## Rimmer Environmental Consulting, LLC

**Re: Site Plan Review - Byfield Estates Comprehensive Permit Application  
Response to Reviewer Comments Feb. 8, 2018**

FIGURE 3

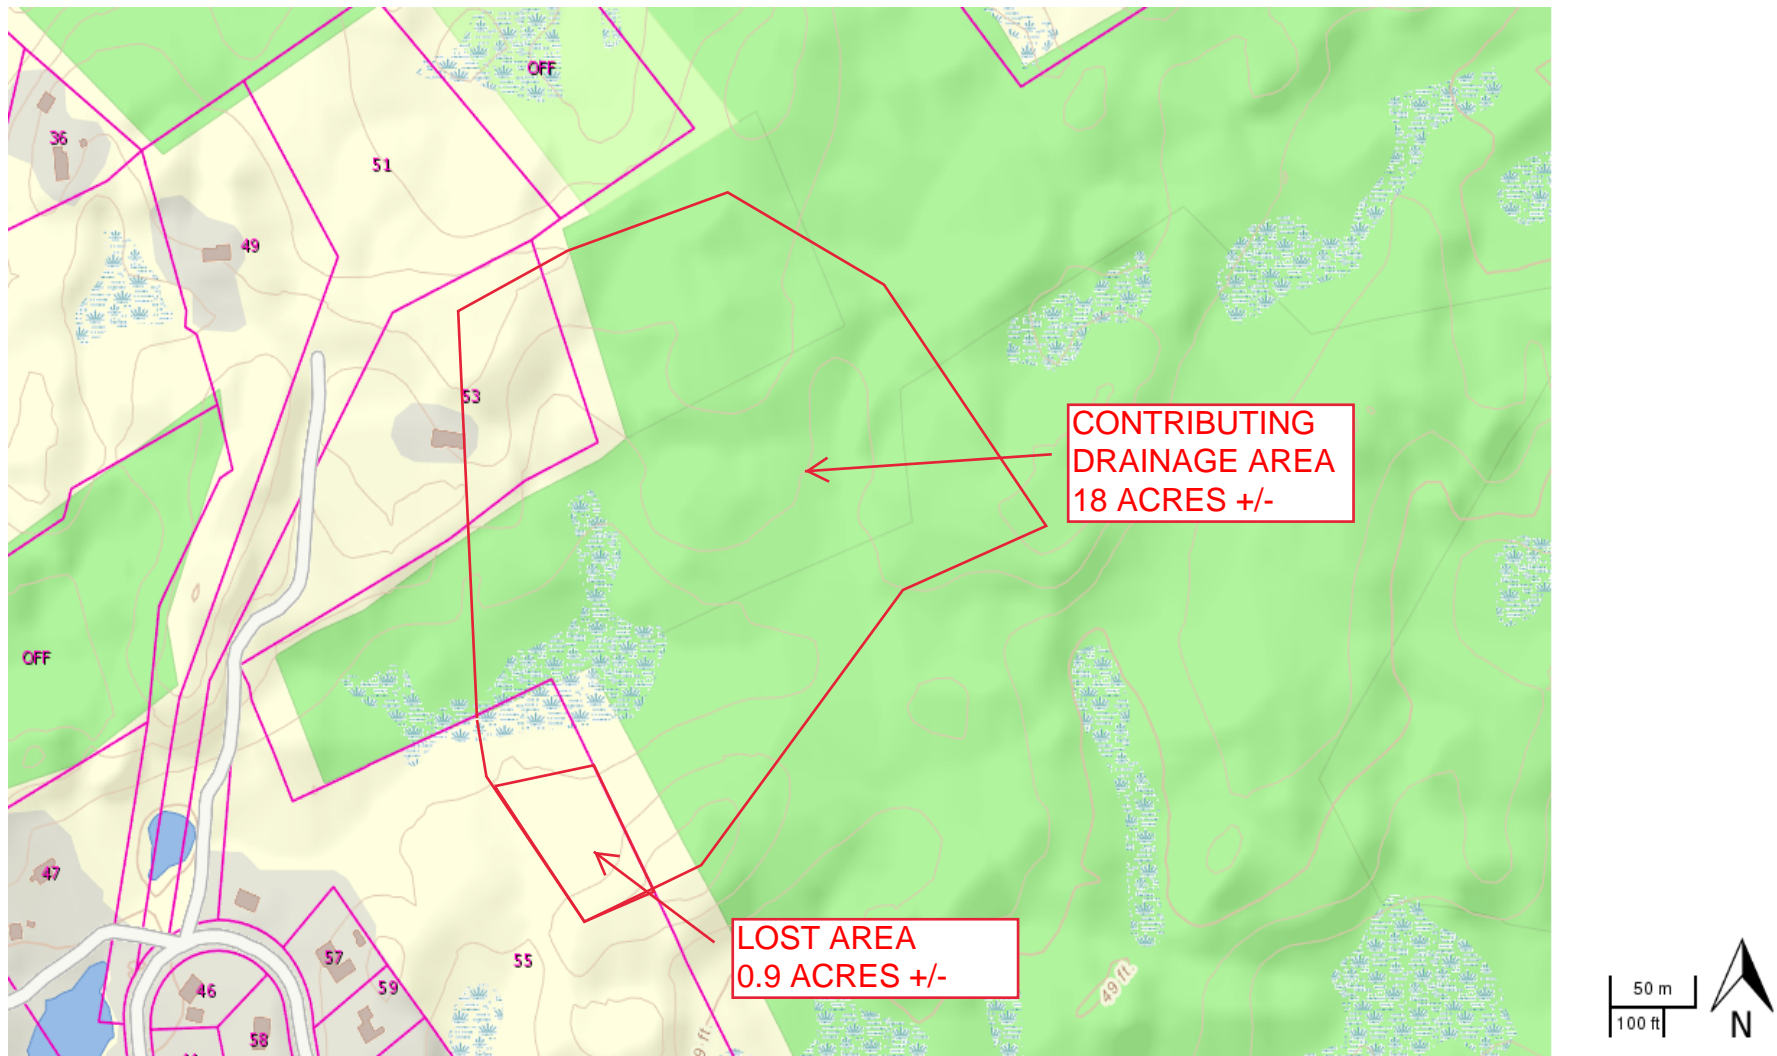
6. *Project Impacts to Vernal Pool Hydrology:* The project has been designed to balance pre- and post-development hydrology contributing to the vernal pools/wetland systems. The pre and post-development watersheds contributing to the two vernal pools was calculated by Ranger Engineering on Figures 3 and 4 attached. The vernal pool abutting state land in wetland D has an approximately 18 acre watershed and the project will reduce that contributing watershed area by .9 acres or 5%. This change occurs at the most downstream end of the wetland where the pool is located, where the change has the least potential for impact to the hydro-period of the pool. In addition, groundwater contributions from the immediately adjacent watershed are likely to be greater due to infiltration from the septic treatment areas, more than off-setting any change in the watershed area. All discharge from the septic system is presumed under Title V to be clean.

FIGURE 4

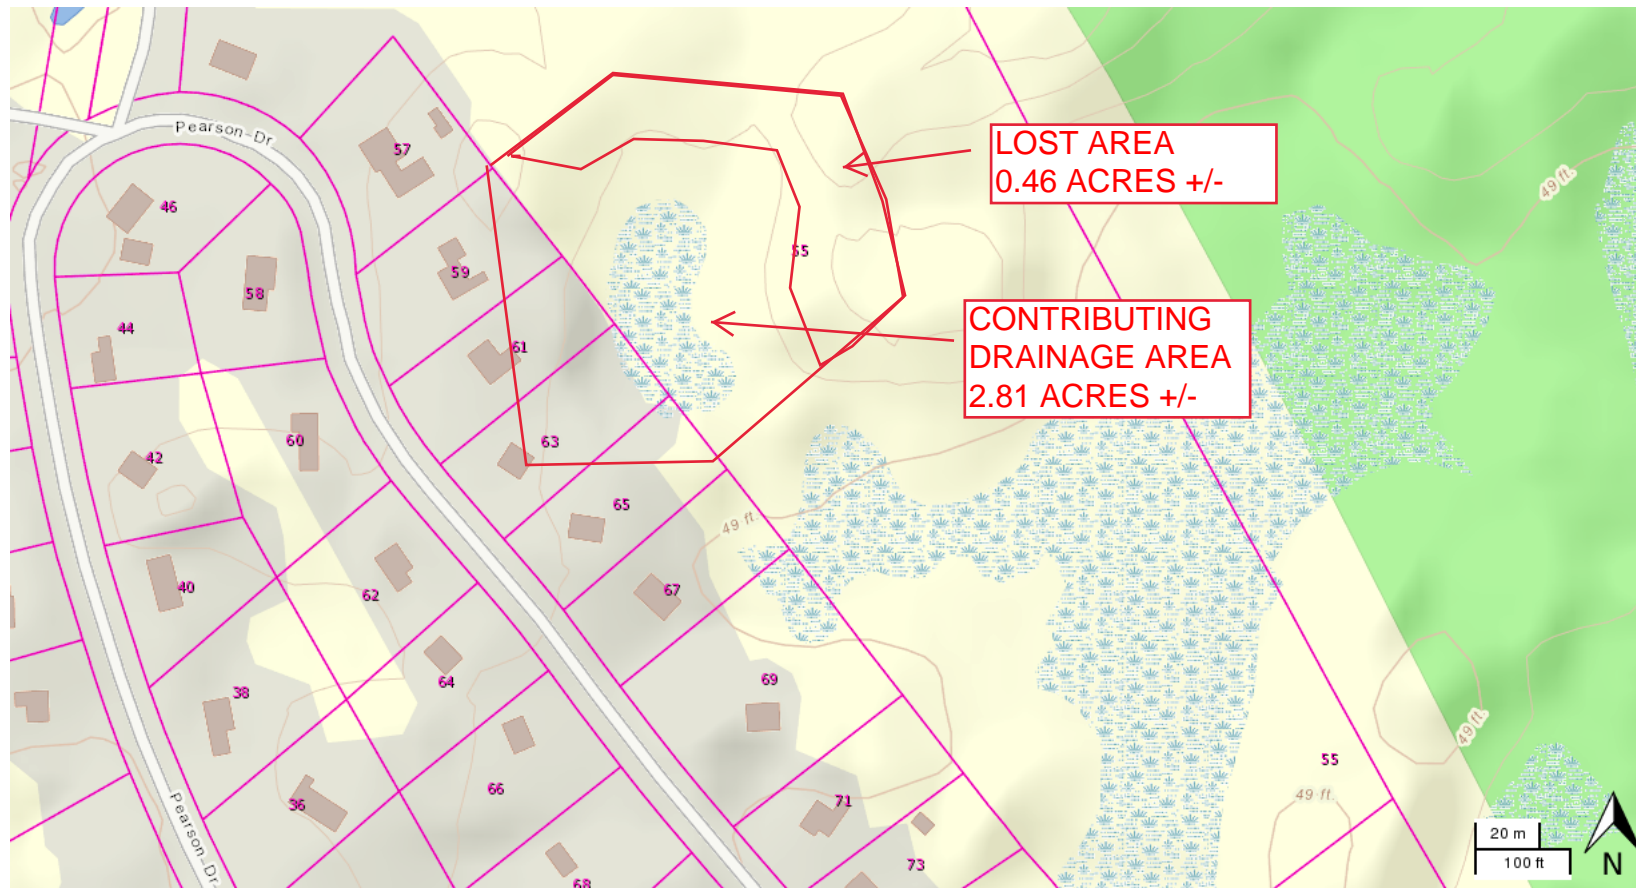
The contributing drainage area to the vernal pool in Wetland A is much smaller, at 2.81 acres. It is being reduced by 0.46 acres or 16%. Groundwater contributions are expected to be similar to existing conditions by infiltrating roof runoff in this area, resulting in no significant change to the hydrology of this pool.
